**Committee of Experts on the Transport of Dangerous Goods
and on the Globally Harmonized System of Classification
and Labelling of Chemicals****Sub-Committee of Experts on the Transport of Dangerous Goods****Forty-third session**

Miscellaneous proposals for amendments to the Model Regulations
on the Transport of Dangerous Goods: portable tanks**Amendment to paragraph 6.7.2.19.8 of the Model
Regulations****Transmitted by the expert from Spain¹****Proposal**

Annex

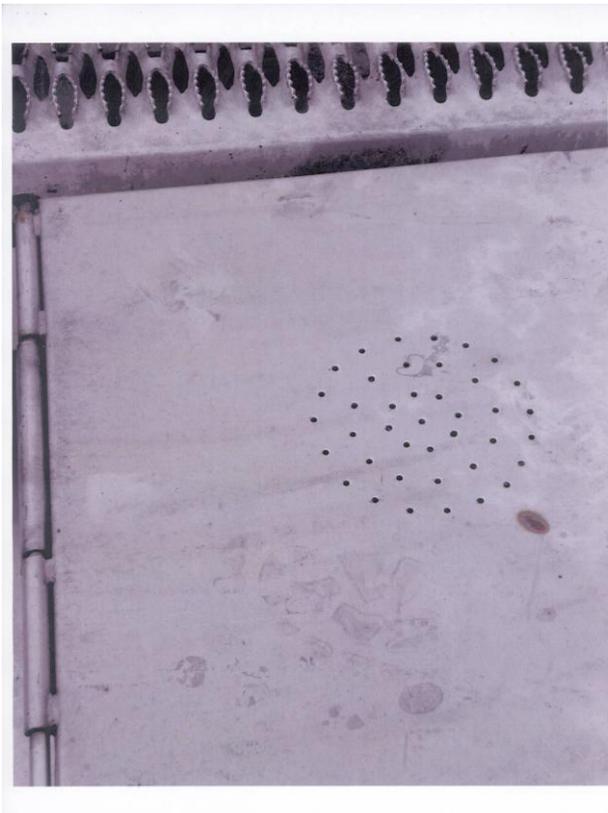
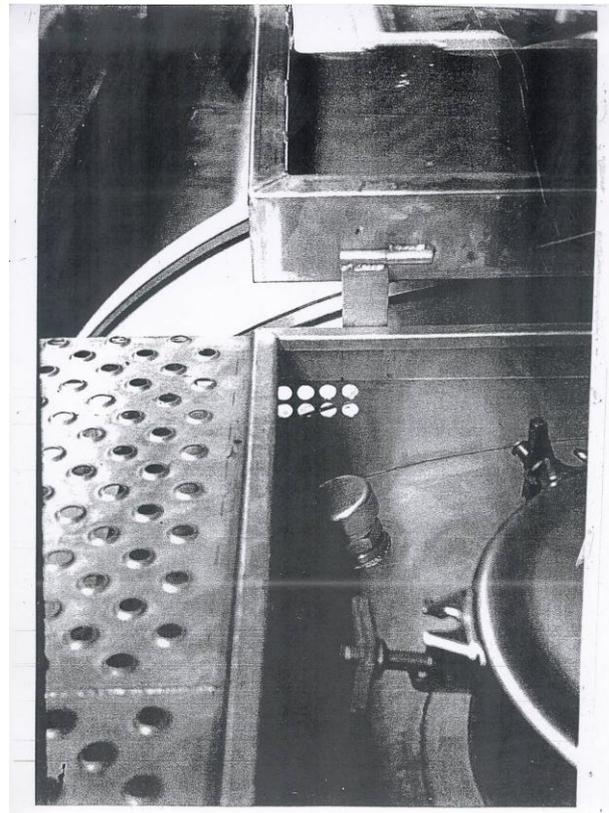
5. In a similar way, other irregularities affecting portable tanks have been detected during inspections done in harbours, in which for example the protective devices that deflect the flow of the escaping vapour of the relief devices were non existing or inappropriate (see pictures annexed).

Also the shell is inspected for pittings, corrosions or abrasions, dents, distortions, defects in welds or any other conditions, including leakage, that might render the portable tank unsafe for carriage;”.
2. Additionally the expert from Spain proposes to add a new sub-paragraph 6.7.2.19.8 (i) to read:
“(i) Protective devices, when existing, which deflect the flow of the escaping vapour of the pressure relief devices, shall be examined to ensure that they do not reduce the relief capacity of the pressure relief-system of the portable-

tank and, in case of portable tanks designed to transport flammable substances, the escaping vapour is directed away from the shell, in accordance with the requirement of 6.7.2.15.1”.
